Summit at Thompson Creek Staff Report

LD 2022.0109

Subdivide 34.57 acres into 109 single-family residential lots

Approval with conditions

Attachment 1:
The Summit at
Thompson Creek
site plan

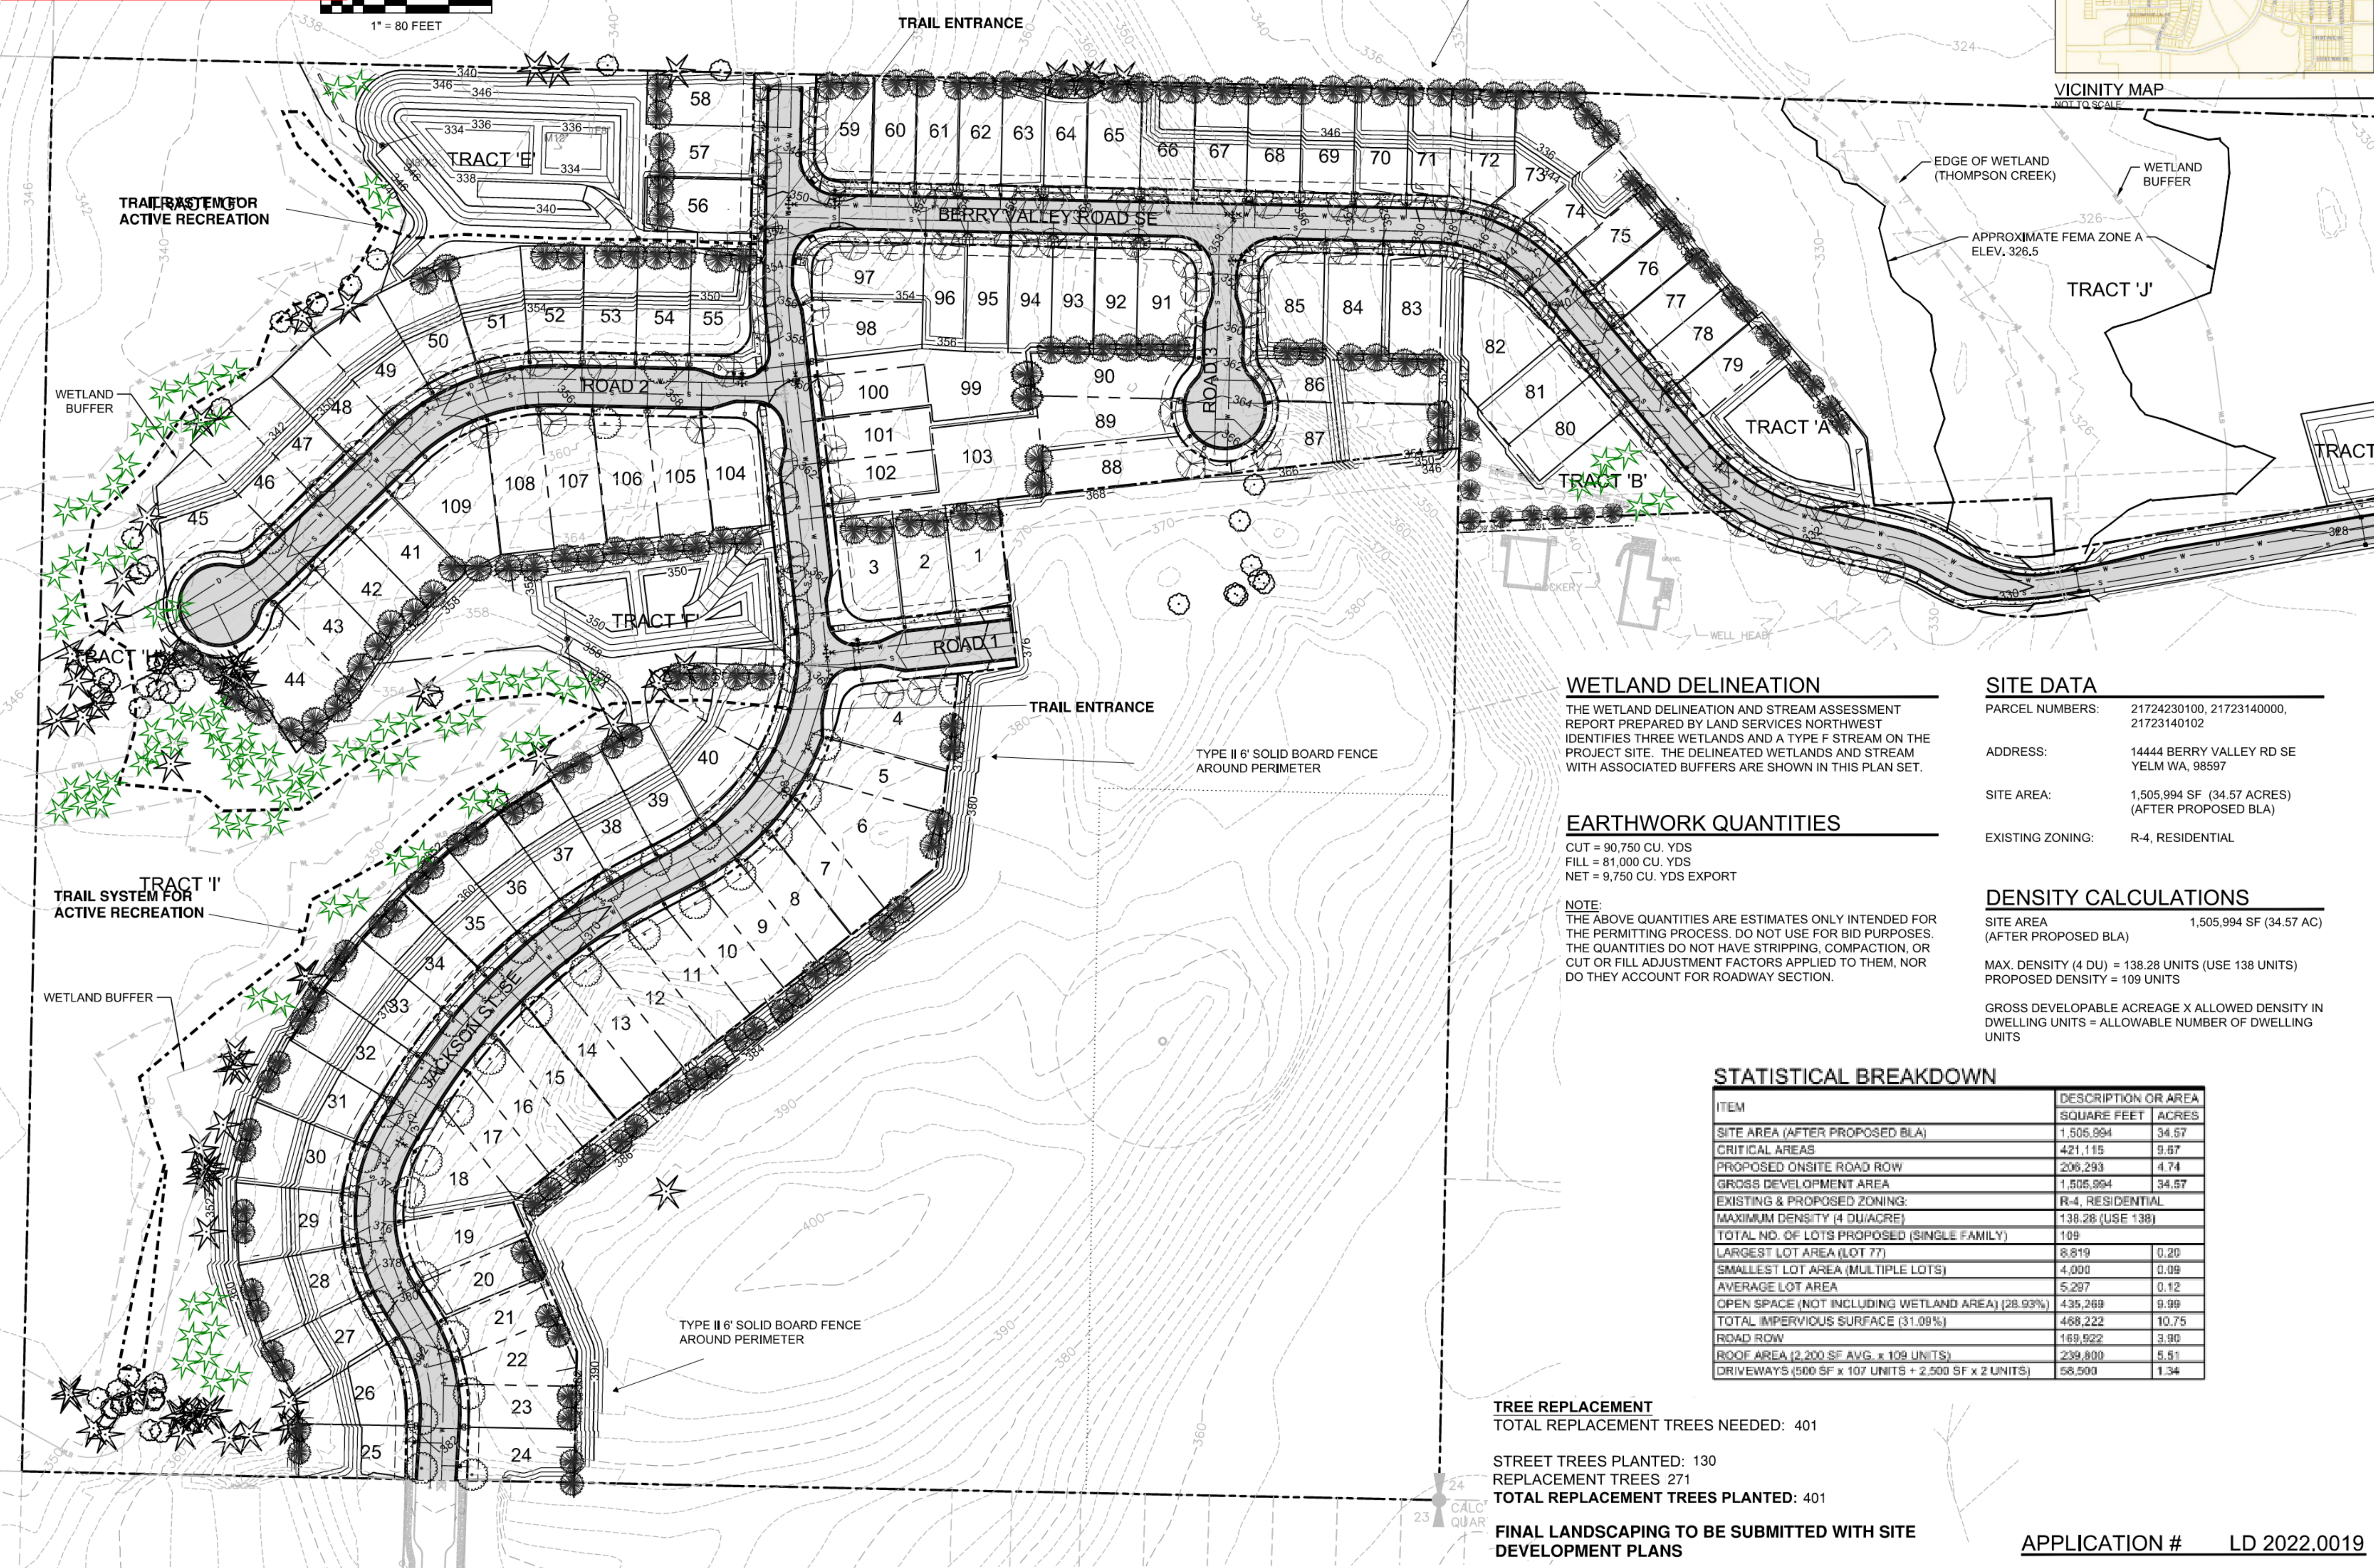
8. SE Thurston Fire Authority has requested two additional fire hydrants: one at the cul-de-sac at the termination of internal 'Road 2' and one near Thompson Creek. The exact location and provision of fire hydrants is finalized during Civil Plan Review. The applicant shall submit a fire hydrant plan that is subject to review and final approval during Civil Plan Review.

10. In order to provide a more complete active recreation component in the required open space area, the applicant shall install at least one play structure in at least one of the open space tracts during site development.
